**Environmental Impact Assessment (EIA) Ordinance, Cap.499
Application for Variation of an Environmental Permit**

**Project Title: Improvement to Fresh Water Supply to Cheung Chau
(Application No. VEP-454/2014)**

Pursuant to Section 13(5) of the EIA Ordinance, we have amended the Environmental Permit (EP-392/2010). We attach the Environmental Permit as amended (No. EP-392/2010/A) for your use.

Environmental Permit No. EP-392/2010/A
環境許可證編號 EP-392/2010/A

Figure 7: Levels of Entry and Exit Pits
圖七：入口及出口工作井的高度

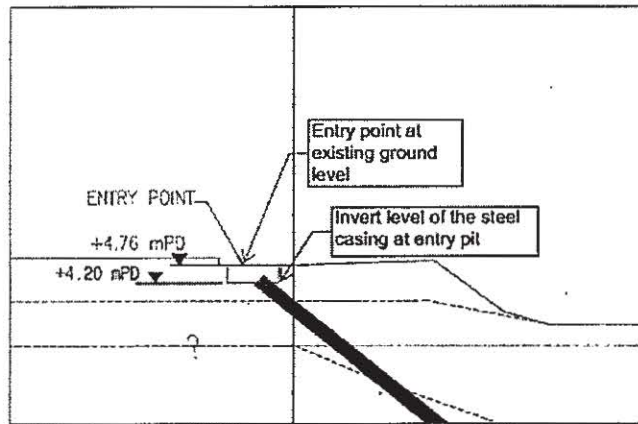
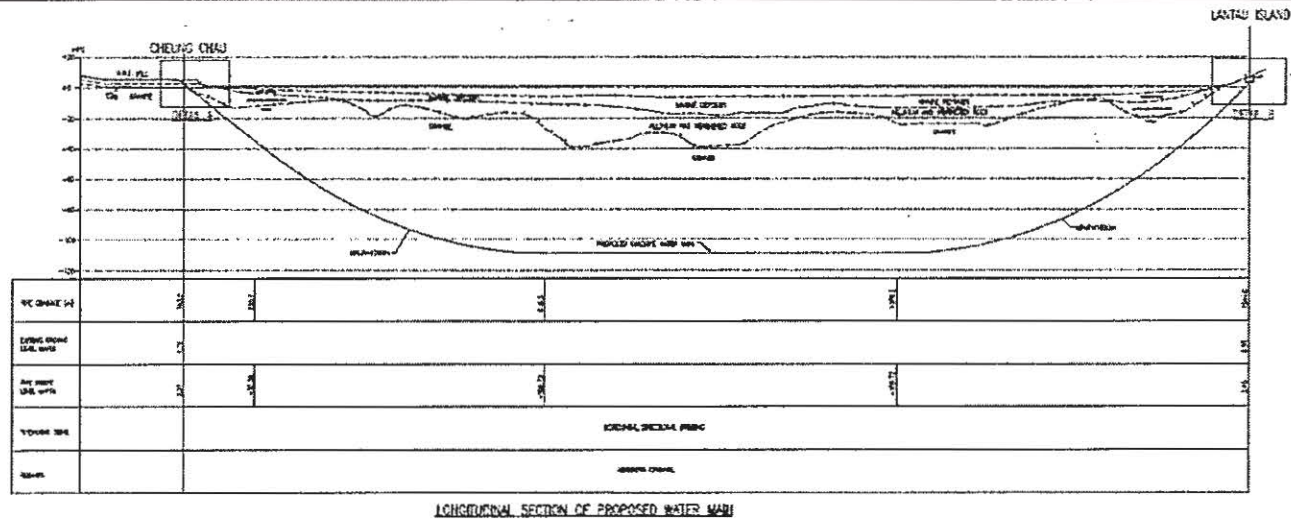
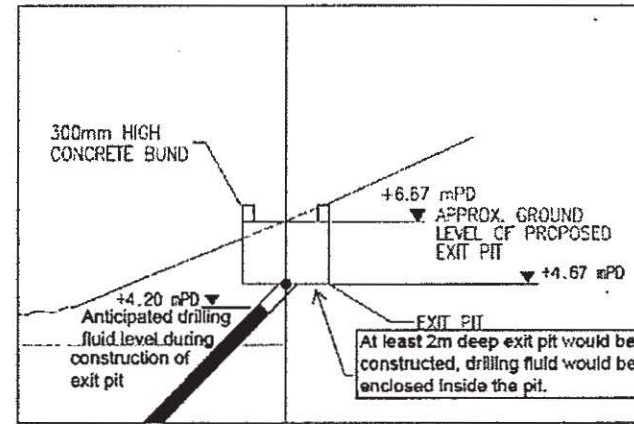
Application No. 申請書編號	Date of Application 申請日期	List of Amendments Incorporated into Environmental Permit 已包含在環境許可證內的修訂項目	Date of Amendments 修訂日期
VEP-454/2014	21 November 2014 2014 年 11 月 21 日	1) Vary Conditions 3.8c in Part C of the Environmental Permit (No. EP-392/2010) (一) 更改環境許可證(編號 EP-353/2009) C 部的第 3.8c 項條件 (2) Add Figure 7 to the Environmental Permit (No. EP-392/2010) (二) 加入環境許可證(編號 EP-392/2010)圖 7	19 December 2014 2014 年 12 月 19 日

- c) All HDD operations shall terminate at least 2 metres below ground surface of the exit point at Lantau Island. A 300 mm high concrete bund shall be provided around the exit pit as indicated in Figure 7. No release of drilling fluid is allowed outside the exit pit at Lantau Island.

所有定向鑽挖運作須於離大嶼山出口井的地面以下最少兩米終止。如本許可證圖 7 所示，出口井須以 300 毫米高的混凝土壘圍繞。鑽井液不可排放於大嶼山的出口井外。
